Optional Cable Resistance Measurement

GITESH BHAGWAT, ANDY GARDNER, HEATH STEWART
SANTA BARBARA DESIGN CENTER

Figure 104-10—Reset command timing diagram

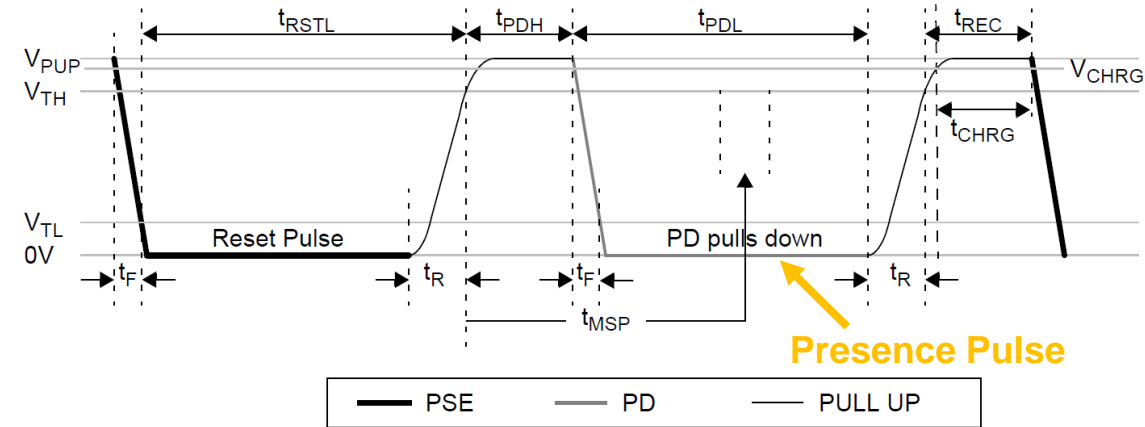
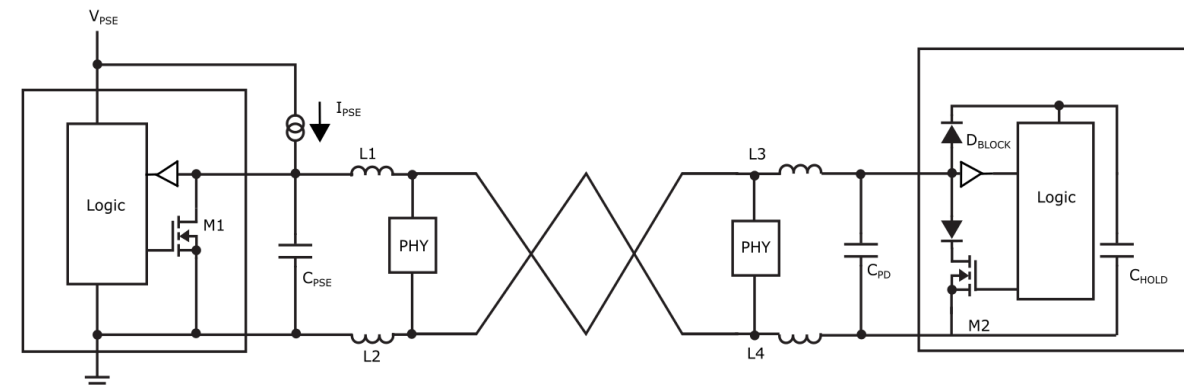
- ▶ Each SCCP transaction is initiated with a PSE Reset Pulse followed by PD Presence Pulse
 - ▶ While the PD is pulling down for the presence pulse, the PSE can measure current and voltage at its PI and calculate cable resistance
 - ▶ However, variability of PD Pull down voltage can introduce significant error in calculated resistance
 - ▶ To eliminate this uncertainty, PD reports to PSE the voltage at its PI during the presence pulse
 - This can be implemented with an ADC measuring and reporting the Pull down voltage at PD's PI
- OR
- With a voltage shunt regulating a constant voltage and reporting that voltage

SCCP Flowchart

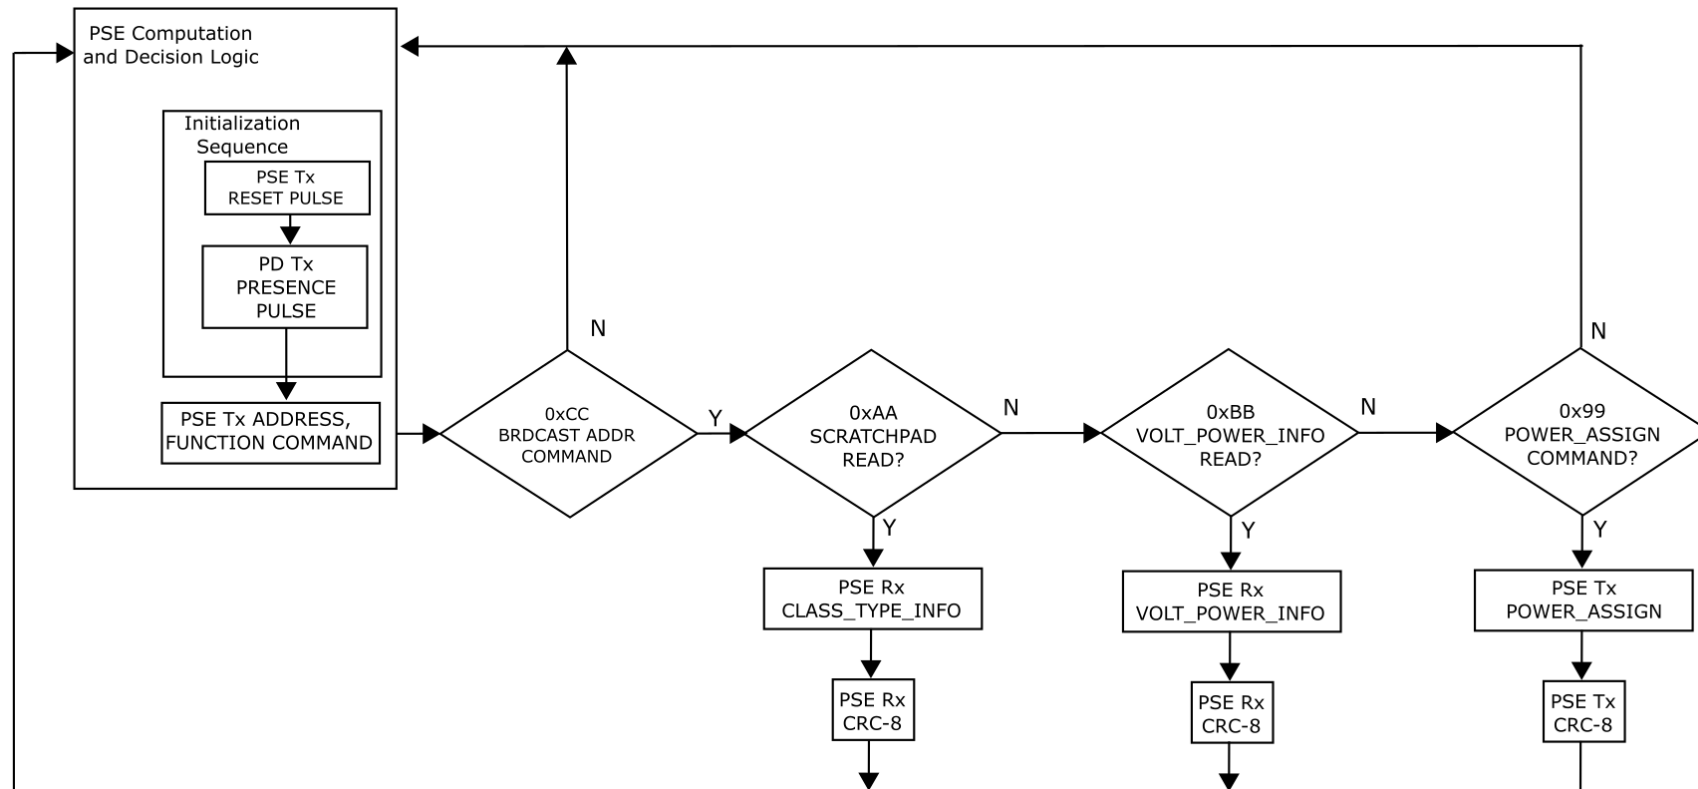
- ▶ Add Two SCCP Commands:
 - 0xBB : VOLT_POWER_INFO Read
 - 0x99 : POWER_ASSIGN Write
- ▶ Replace Figure 104-13 with the figure shown on this slide
